UNITED STATES PATENT AND TRADEMARK OFFICE

APPLICATION NO.	FILING DATE	FIRST NAMED INVENTOR	ATTORNEY DOCKET NO.	CONFIRMATION NO.
10/743,424	12/23/2003	Yunggyo Lee	031345	7516

Office Action Summary

DETAILED ACTION

FIG. 1

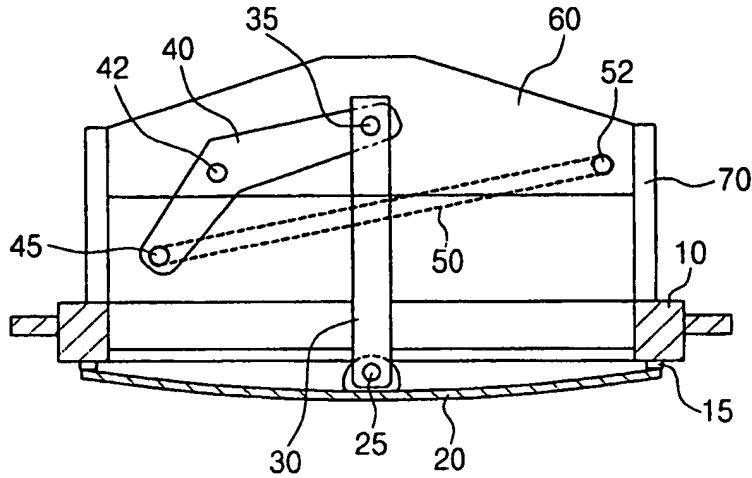
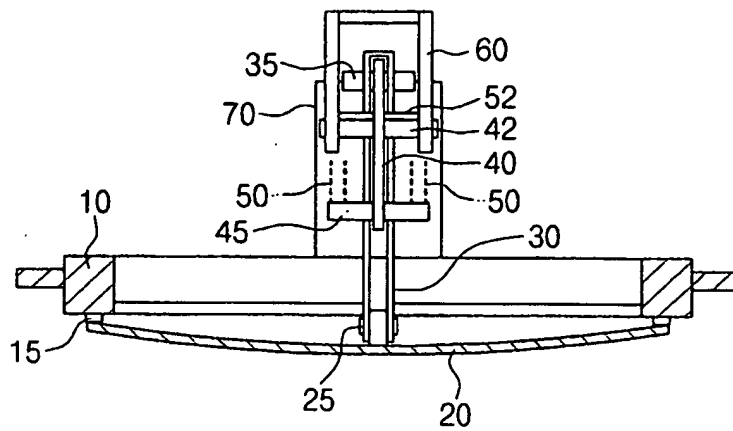
4. Claims 1-7 are rejected under 35 U.S.C. 103(a) as being unpatentable over applicant's admission to the prior art (APA) as shown in Figures 1 and 2, in view of Chlebek et al. (US 5,513,395).

APA discloses a safety valve operated by differential pressure, the valve comprises of a valve body (10), a valve disk (20), a central link (30), a link (40), an elastic member (50), the valve disk (20) being mounted on the valve body (10), the central link (30) being connected at one end to the valve disk (20), and opening and closing the valve, the link (40) being connected pivotally at one end to the central link (30), and making the central link (30) move according to rotation of the link (40) around a link pivot (42), the elastic member (50) being connected pivotally at one end to the link (40,45) and fixed pivotally at the other end (52), and making the link rotate around the link pivot (42) by elastic force of the elastic member (50), the member being mounted on the other end of the central link (30).

APA lacks a non-magnetic member attracted by a magnet.

Regarding claim 2, APA discloses a gasket (15) located between the valve body (10) and the valve disk (20).

Regarding claim 3, APA discloses the elastic member is a spring (50).

Therefore, it would have been an obvious matter of design choice to modify the prior art as shown in Figure 1 and 2 in view of Chlebek et al. to obtain the invention specified in claim 5.
